Amendments to the Drawings:

REMARKS

FIG. 3

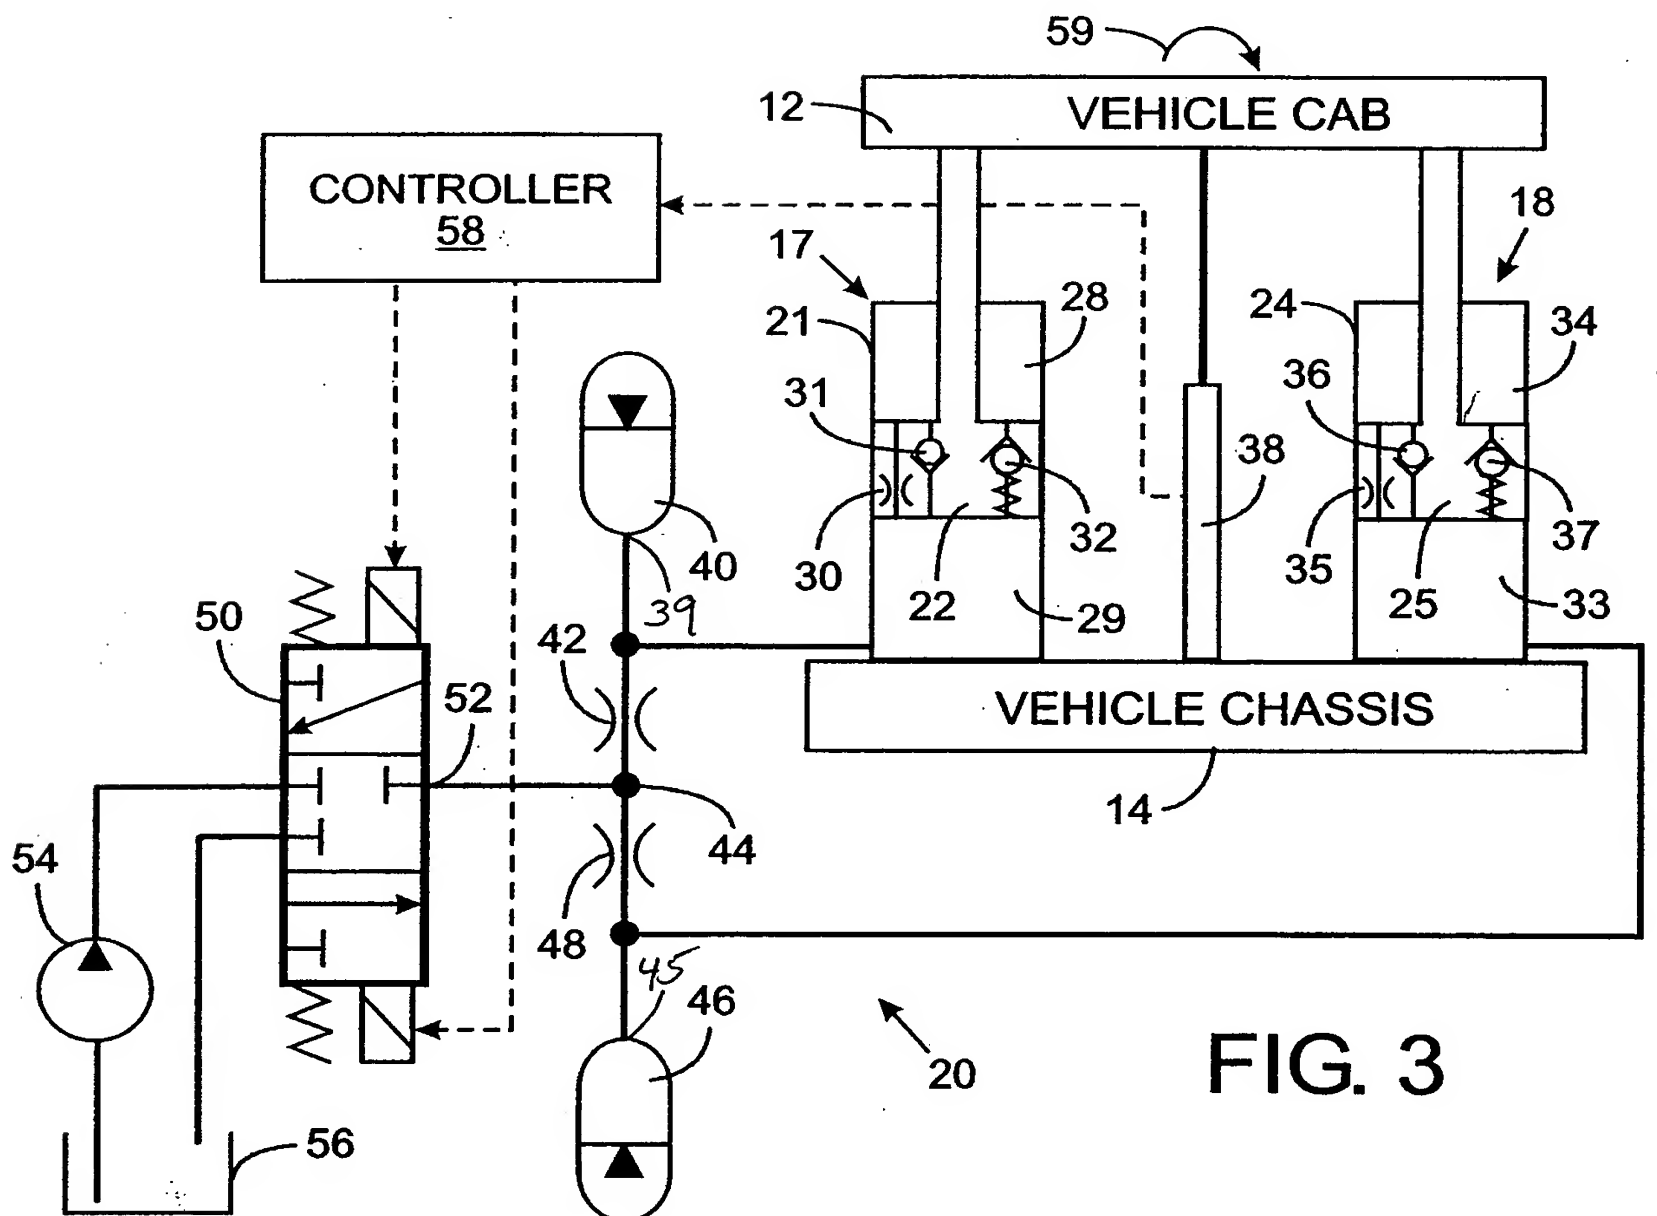
The drawings were objected to because “it is unclear in the figures where the accumulator ports are located.” As a conventional accumulator has only a single port, one skilled in the art would understand that the port is located where the hydraulic line attaches to the accumulator. Nevertheless, in the attached sheet of drawings reference numeral 39 has been added to indicate the first port 39 of the first accumulator 40 and reference numeral 39 has been added to indicate the second port 45 of a second accumulator 46. The specification has been amended to refer to these numerals.

The attached sheet of drawings includes changes to Figure 3 as requested by the Examiner. Specifically reference numeral 39 has been added to indicate the first port 39 of the first accumulator 40 and reference numeral 39 has been added to indicate the second port 45 of a second accumulator 46.
